Internal Memo Community Services Department

Subject:

Official Plan Amendment (OP17/003/F/GS) and Zone Change Application

(ZC17/010/F/GS) - 507 Frederick Street, 40, 44 and 48 Becker Street

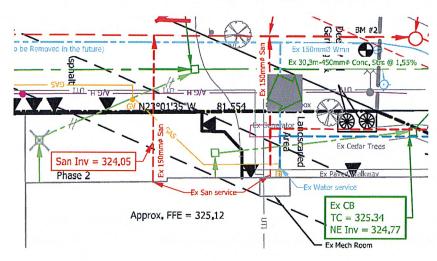
MTO has initiated the detail design of Frederick Street underpass (GWP 408-88-00 Highway 7 New, Kitchener to Guelph, Detailed Design of the Grand River Crossing, Preliminary Design of other Highway/Structural Elements – Woodlawn Rd. Interchange Reinstatement, Reference Concept Design), where additional consultation will be occurring regarding maintaining access during construction staging.

To ensure time and space requirements can be achieved between contractors working on the 507 Frederick St development and the MTO contract, MTO requires the anticipated timeline and duration of the proposed works on 507 Frederick St.
